Attachment E

Submissions

From: Sherri Fields
Sent on: Monday, May 6, 2024 11:31:49 AM
To: council
Subject: 2-4 Raper St, Surry Hills - D/2024/214 - feedback

We are writing to you in relation to DA/2024/214 at 2-4 Raper Street Surry Hills 2010 for alterations and additions to the existing Brett Whiteley Art Studio including construction of a new roof form and facade upgrades.

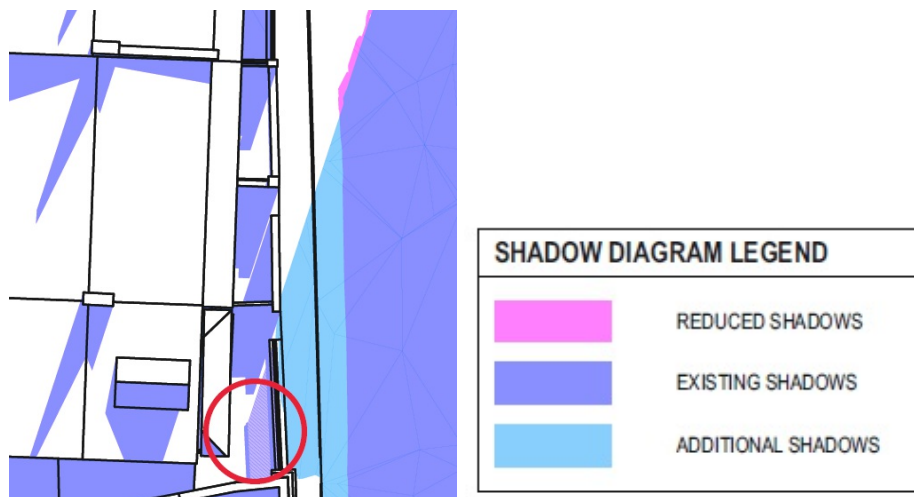
Based on the expanse of area available on the roof, the existing peak to the east, and roof voids evident in the architectural sections, we believe it would be possible to house the mechanical plant with no solar access impact to neighbouring properties. This would obviously require test fits and an efficient mechanical layout, and the amenity of neighbours to be considered more important than the architect's "Whiteley inspired wave form".

We would also like to note, referring to the below sippets, that having *existing shadows* and *additional shadows* as such similar colours in the shadow diagrams is deceptive. There also seems to be a fourth colour with no obvious note on the legend (refer the red circle in the snippet below).

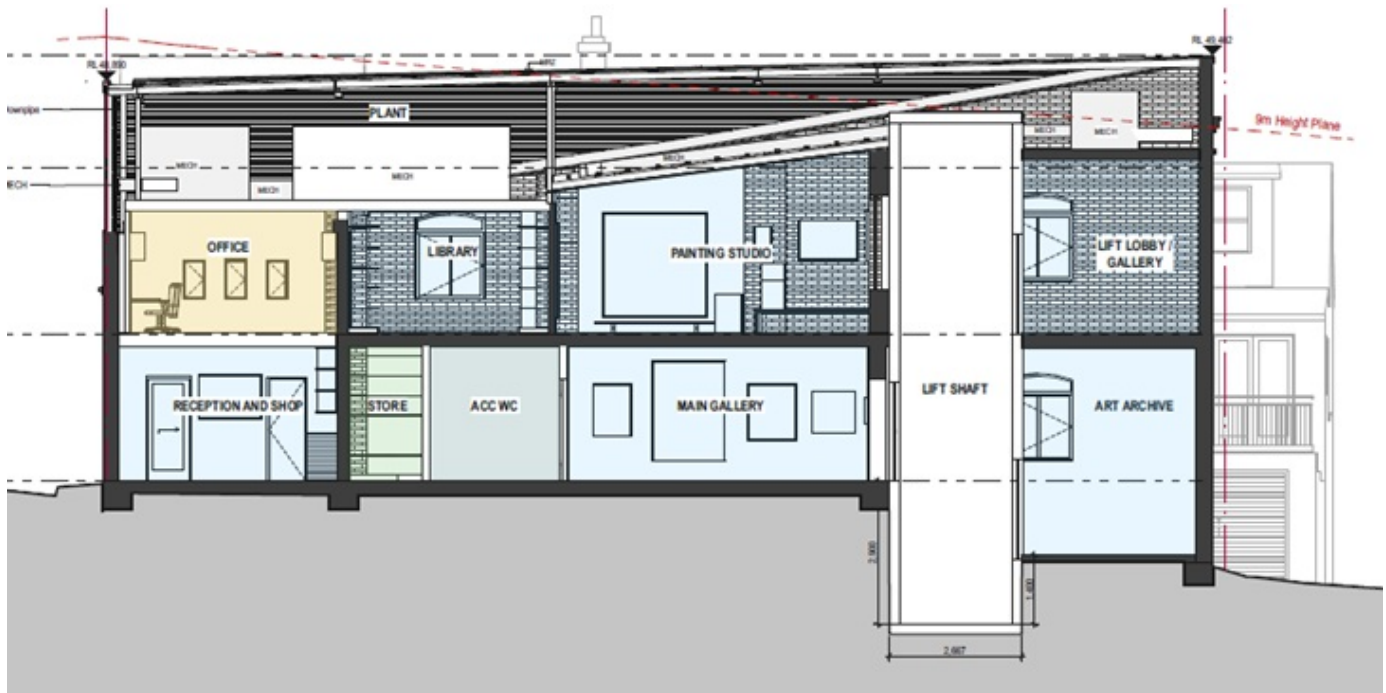
We understand and respect that the CoS requires that the mechanical plant be wholly contained within the new roof form; however, the proposed form is "overkill" and far more than necessary to house the plant required to service a gallery of this size (even when running 24hrs/day). As mentioned above, and as shown in the below snippet, there is ample space for the plant to be pushed further east which would realise a reduction in roof height and bulk to Raper Street. This is also a better location for noise producing plant as it places it away from Raper Street bedrooms (the current proposal quite literally could not place the mechanical equipment any closer to residential, habitable rooms).
